ARCHITECTURAL REVIEW BOARD MEETING  
CITY HALL, 385 SOUTH GOLIAD STREET, ROCKWALL, TEXAS  
**FEBRUARY 24, 2026** IN THE CITY COUNCIL CONFERENCE ROOM AT 5:00 PM

## PLANNING AND ZONING COMMISSION CASE MEMO

**TO:** Planning and Zoning Commission  
**DATE:** February 24, 2026  
**APPLICANT:** Salvador Salcedo  
**CASE NUMBER:** SP2026-002; *Site Plan for 855 Whitmore Drive*

02/20/2026: SP2026-005; Site Plan for 5013 Coffee [1011 S. Goliad Street]

<b>SITE PLAN</b>	SCALE: 1" = 20'-0"
<b>LOT 10 &amp; 11</b>	
<b>CANUP'S SUBDIVISION</b>	
<b>ROCKWALL, TEXAS</b>

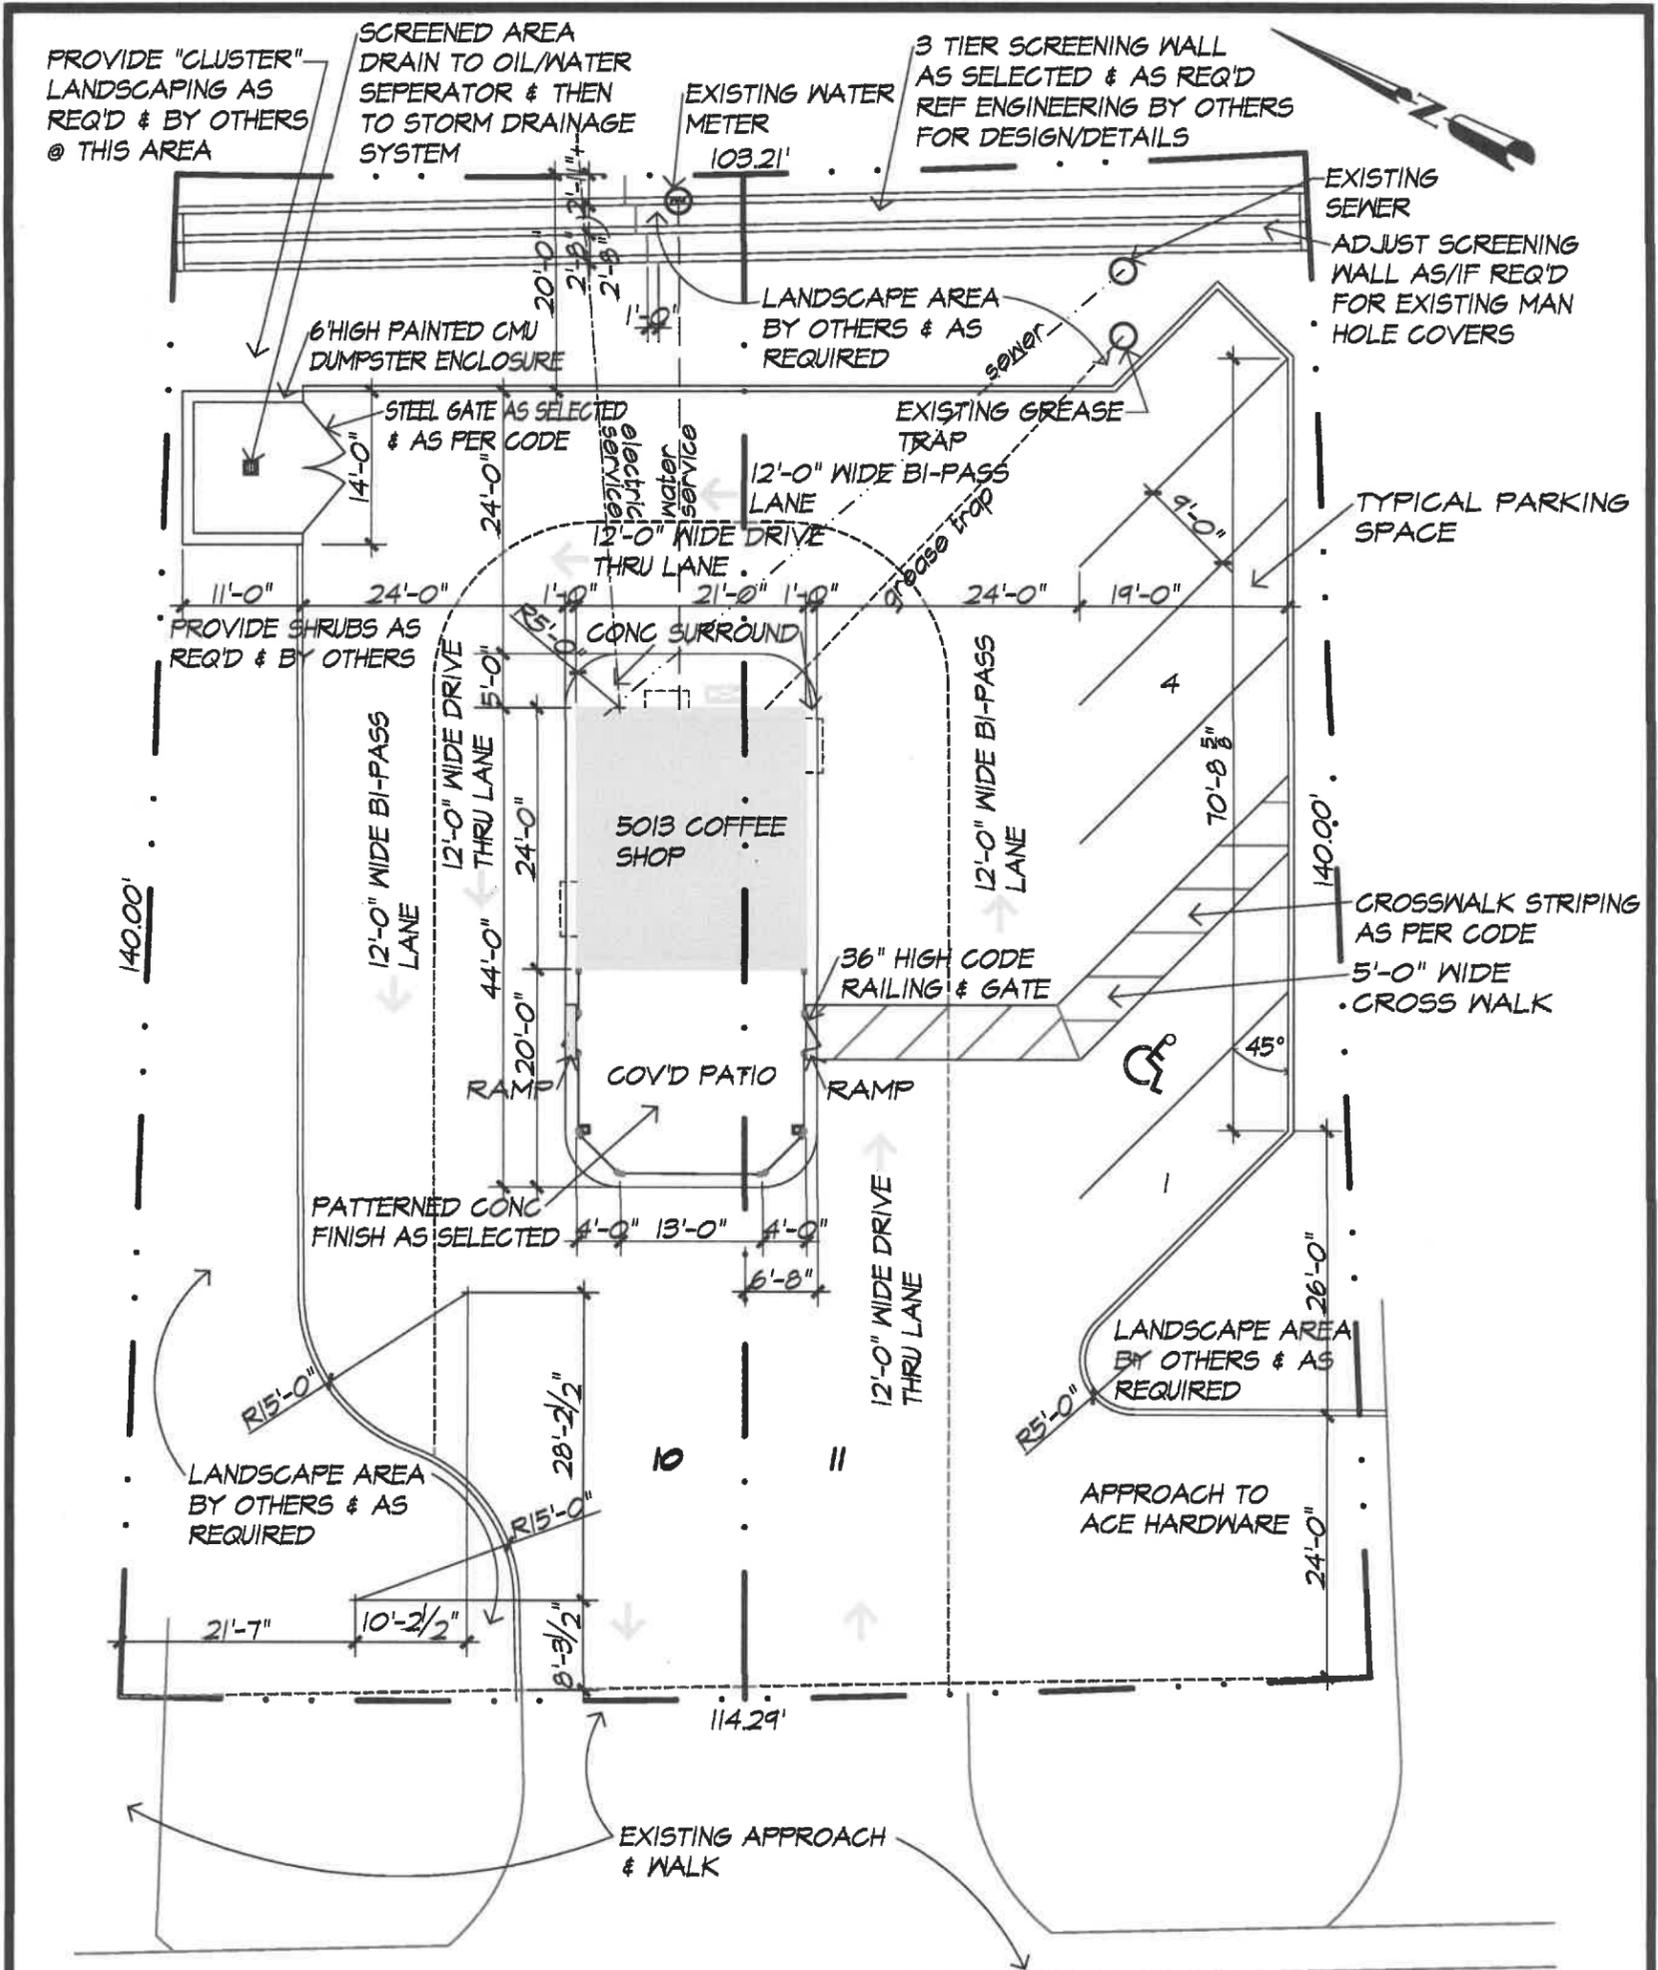
M.9 Please provide a numeric and graphic scale on the site plan. (Subsection 03.04, of Article 11, UDC)

M.10 Please provide a vicinity map on the site plan. This should locate the site relative to the nearest major roadways in a one-half mile radius. (Subsection 03.04, of Article 11, UDC)

- (11) Please label and existing or new fire hydrants. (Subsection 03.04. B, of Article 11, UDC)
- (12) The required parking for Restaurant is one (1) parking space per 100 SF, and remainders are rounded up. Please ensure the correct number of spaces are provided. (Subsection Table 5, of Article 06, UDC)

- (15) Please indicate any existing or proposed fencing. Please delineate the location and provide the material and height. (Subsection 08.02. F, of Article 08, UDC)

- (16) All pad mounted equipment must be shown on the site plan. This equipment must be screened with five (5) gallon evergreen shrubs, which should be shown on the landscape plan. (Subsection 01.05.C, of Article 05, UDC)

- (17) Please provide a note that there shall no above ground storage tanks or outside storage, which includes vehicles. (Subsection 01.05. B, of Article 05, UDC)

- (18) Please provide a detail of the dumpster enclosure. In addition, the dumpster enclosure must be a minimum of eight (8) feet in height and use the same materials as the building. (Subsection 01.05. B, of Article 05, UDC)

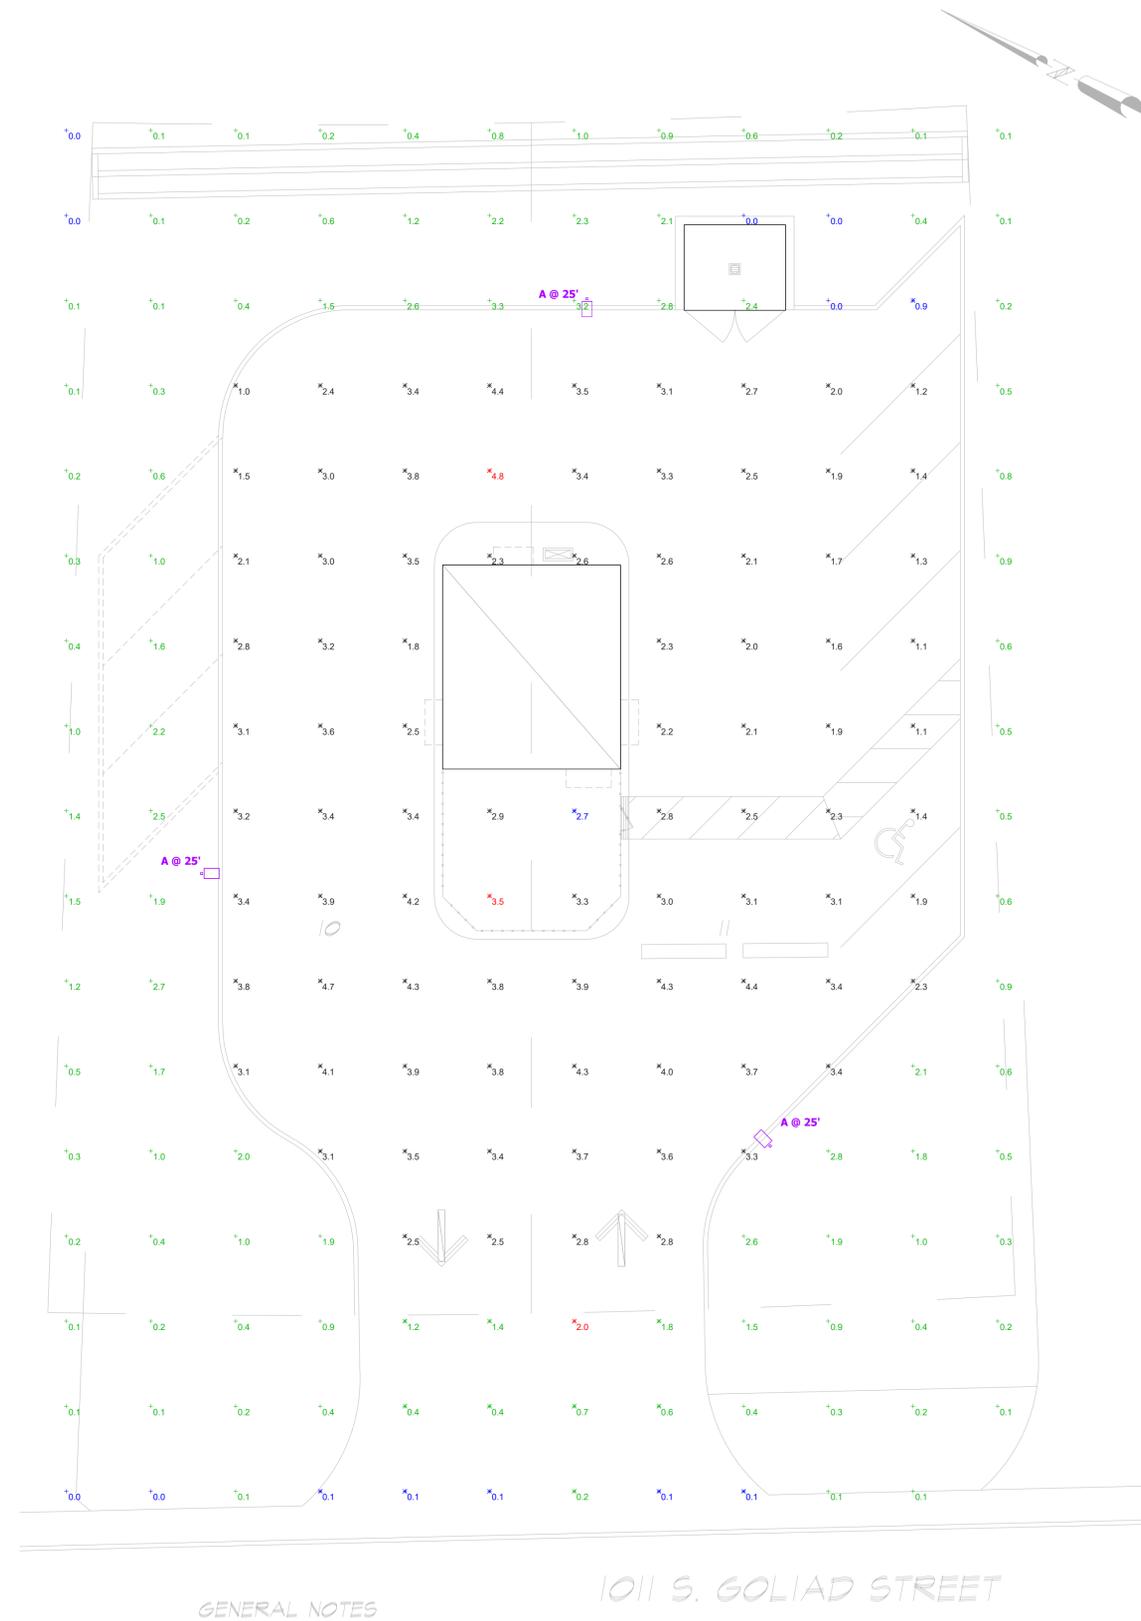
- (1) Provide the same site data information required in Section 2.1 Site Plan: Miscellaneous and Density and Dimensional Requirements of this checklist. (See Sec. 2.1 of the checklist)
- (2) The foot-candles at all property lines must not exceed 0.2 FC. In this case, there are areas on the property where this 0.2 FC requirement is exceeded. Please correct the

photometric plan to address this requirement. (Subsection 03.03, of Article 07, UDC)

(4) Please provide the cut sheets for all of the proposed light fixtures. (Subsection 03.03, of Article 07, UDC)
